15 Fitzroy Street

Non-Material Amendment 2

This NMA brochure explains the non-material design amendment to planning permission ref. 2022/2087/P.

Fig. 2.1 - Consented East Elevation

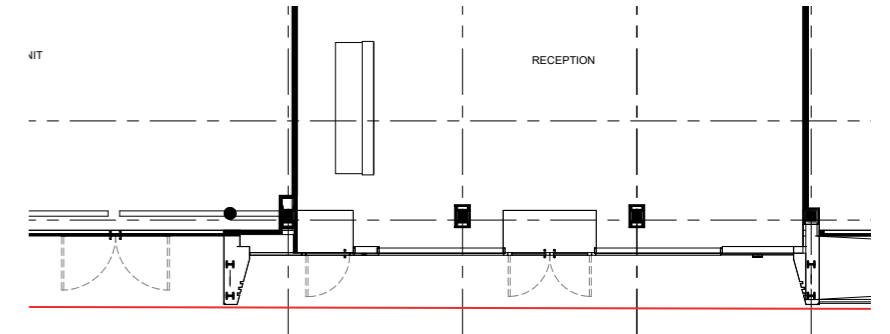
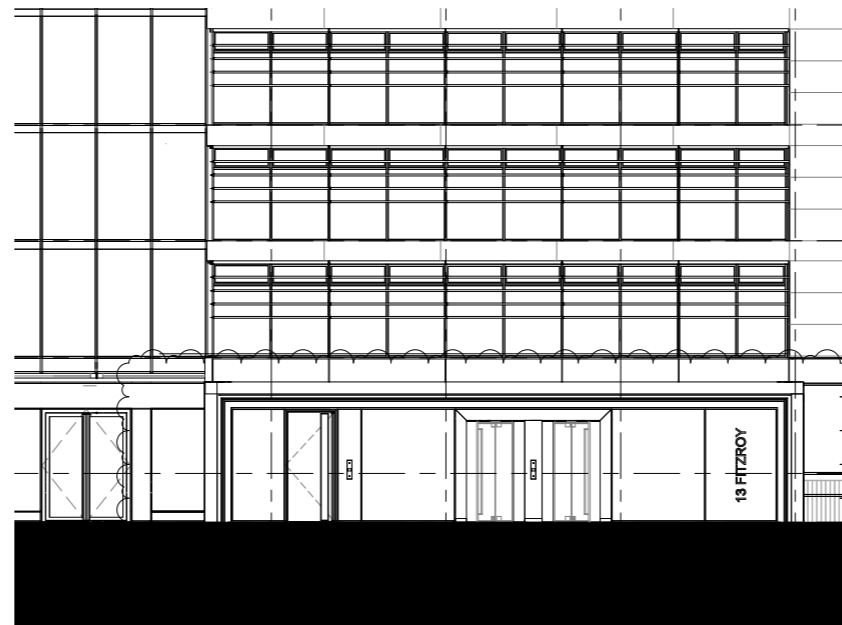
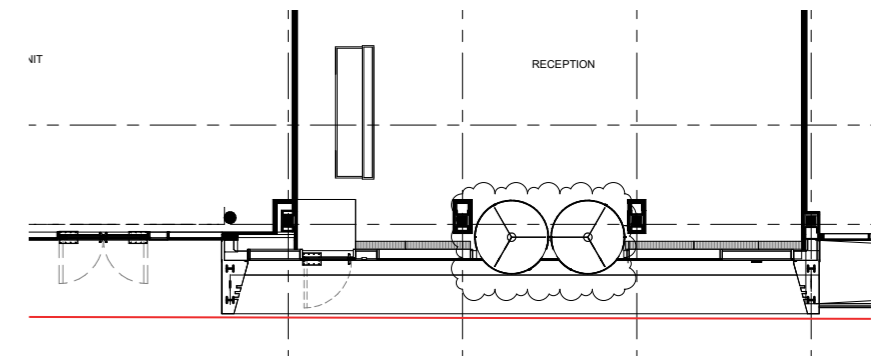
It is proposed to replace the currently consented double entrance door with two revolving doors as it would be more appropriate for the building's occupancy, allowing a more efficient flow of people in and out of the building. The revolving doors also improve the interior climate of the reception by reducing draughts and heat loss.

The revolving doors will remain within the title boundary, within the consented feature entrance portal and the single leaf entrance door will remain as consented to provide access and egress for less-able bodied users.

Fig. 2.4 - Proposed East Elevation

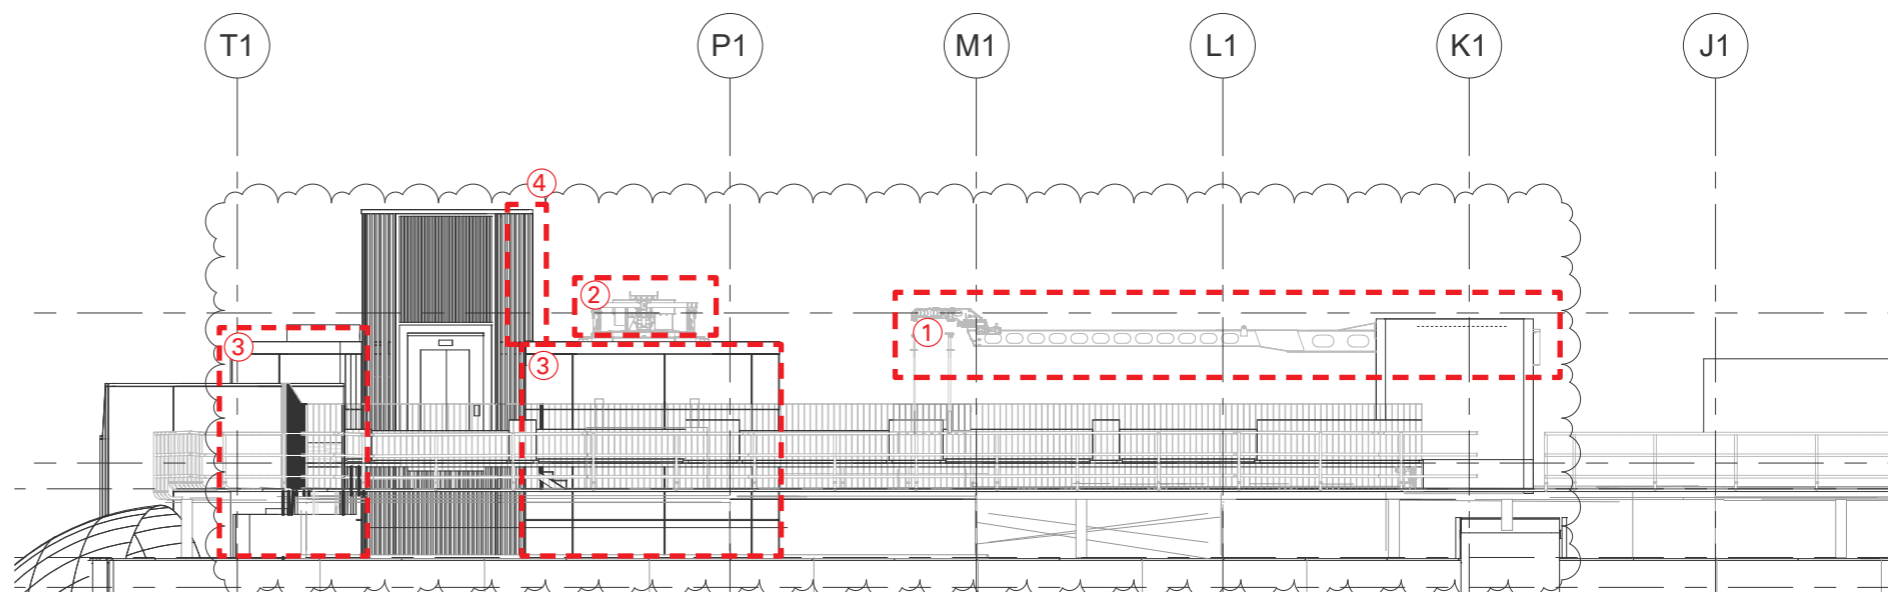
- 1 - 2. The existing building had 2 no. Building Maintenance Units (BMU), installed as part of the 2001 refurbishment works, which covered the existing external facades. Previous drawings did not show the existing BMUs as the original intent was to retain as existing.

Following surveys of the existing equipment and a review of the implications of the redevelopment in line with the Working at Height Regulations and CDM:2015, both existing BMU systems are to be replaced with new systems to better serve the development and conform with modern standards.

Investigations were carried out into the use of large MEWPs to access the facade, however this was disregarded due to the size of machines required and disruption at ground level. Rope Access was not considered as it is the highest risk activity on the hierarchy of risk control, and would not be reasonably practicable to integrate.

Due to the new roof terrace located on the main roof, the previous operating conditions and counterweight clearance of the larger BMU are to be modified to suit. The new BMU will be slightly higher (approximately 700mm) to allow the counterweight to slew clear of the proposed terrace balustrade and new access stair.

3. As per the previous NMA application (ref. 2023/2320/P), the extent of cladding replacement to the core 1 facades approved under the MMA application (ref. 2022/2087/P) has been reduced. The proposed cladding has been limited just to the lift extension.
4. A minor extension of lift cladding to ensure sufficient space for insulation and air between structure and rain-screen cladding is proposed.

Fig. 2.3 - Consented West Elevation

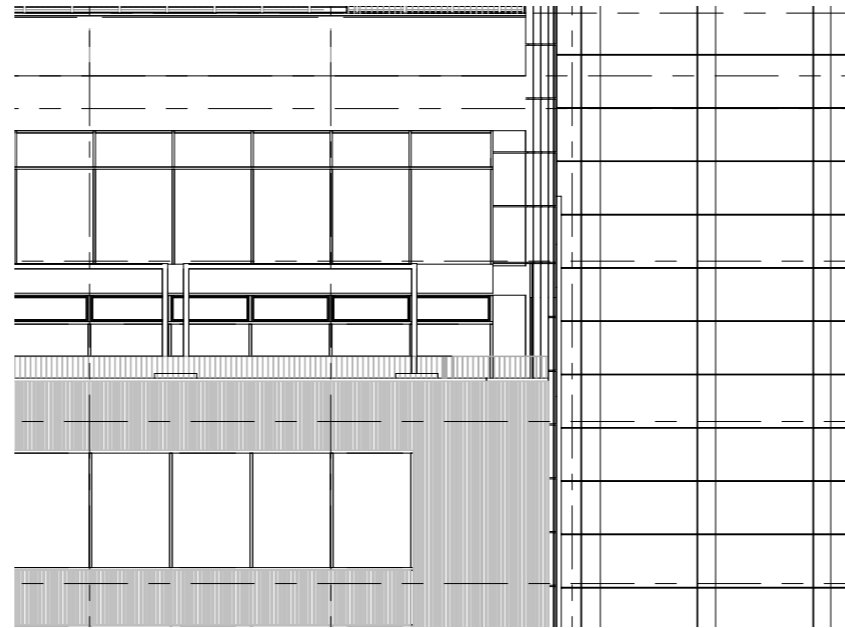
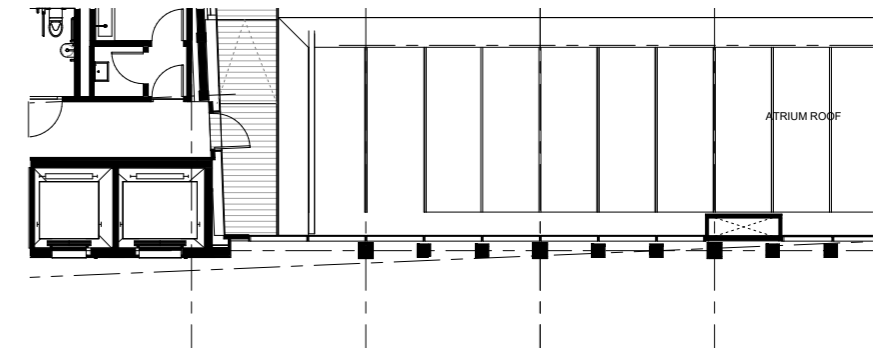
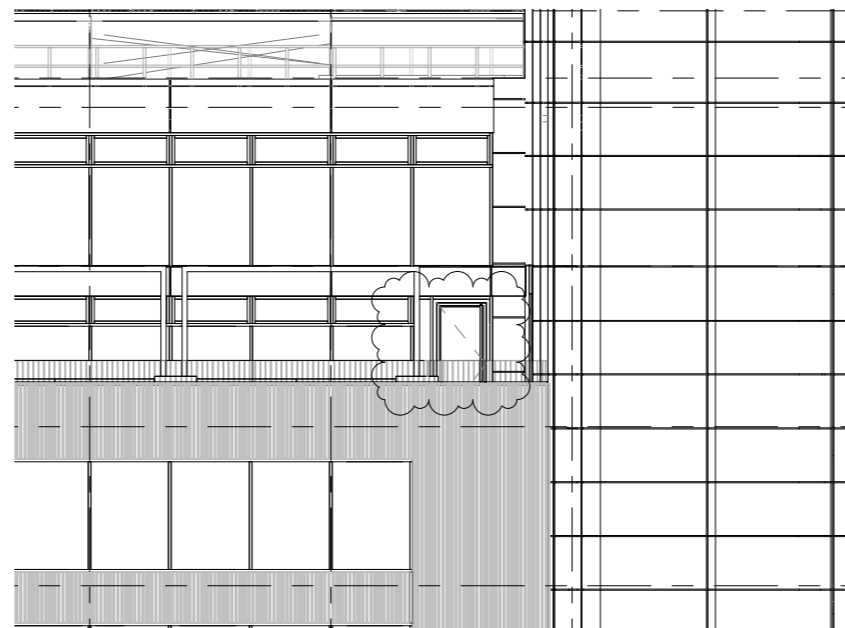
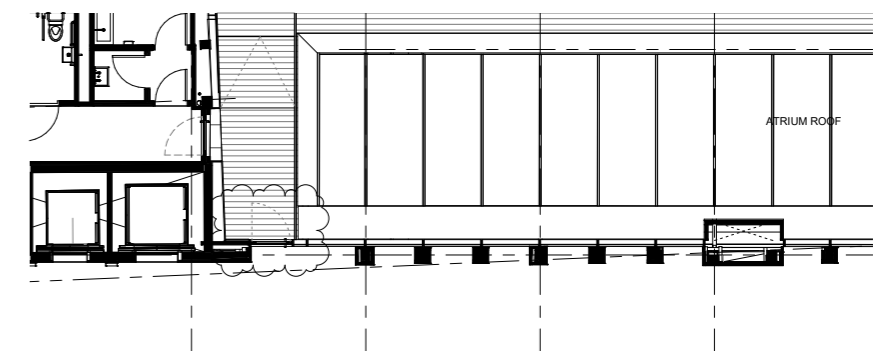
A new single-leaf glazed door is proposed within the existing external curtain wall to provide direct access to the Block B external terrace from the level 05 office floorplate.

The door is proposed to improve circulation and to avoid the need for tenants and their visitors to journey through landlord areas within the core to access the external terrace. The consented access door to the terrace is to be kept in addition, as a more direct route to the escape core in the event of an emergency.
